Reviewers' comments:

The manuscript applies machine learning to a large EIS dataset for commercial lithium-ion batteries to predict cycle number and the remaining useful life (RUL). In summary, this manuscript has some highly significant results that was worthy of publication, but should be revised to be more precise and accurate in the wording of the text. Below are more details comments to this effect, as well as pointing out a few other minor fixes to make.

Figure: Capacity curves during cycling

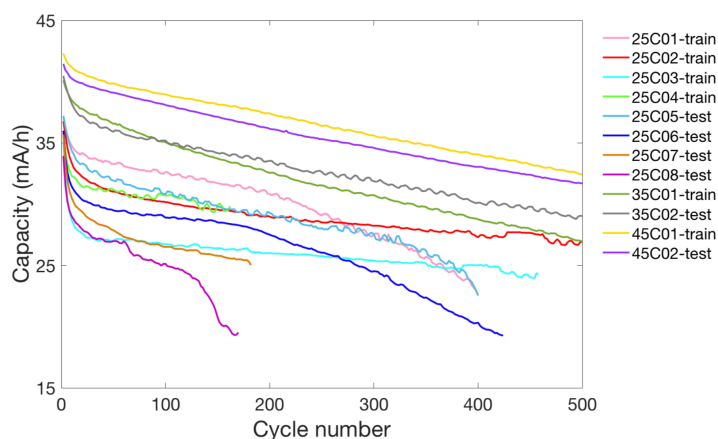
1. Failure of lithium-ion batteries is a non-linear process and makes prediction of battery life and state of health a difficult task. In this study, there is only one set of data being used as a training set at a given condition. This makes the method more of a fitting than machine learning. This seems to be the case that the authors have just one cell for training and one cell for prediction at 3 different temperatures. Even at same cycling conditions, cells tend to fail at a different cycle number due to the inherent non-linearity of the degradation processes in the system. So just using two cells for a condition with one as a training set and other for prediction can at best be a glorified curve fitting than machine learning. Not to mention, the authors try to identify the cycle number rather than the capacity retention.

4. The capacity retention curves of the training set as well as the predictor set should be provided (e.g., in the supplementary information).

We have cycled 6 more cells under 25 °C to test the robustness of our EIS-Capacity model. These six cells failed at different cycle numbers, as the referee expected. Their capacity curves during cycling are shown as below and also in Figure S2 in the Supporting Information (SI).

As the referee suggested, we have added the capacity retention curves of all cells (including training and testing sets) in Figure S2 in the SI.
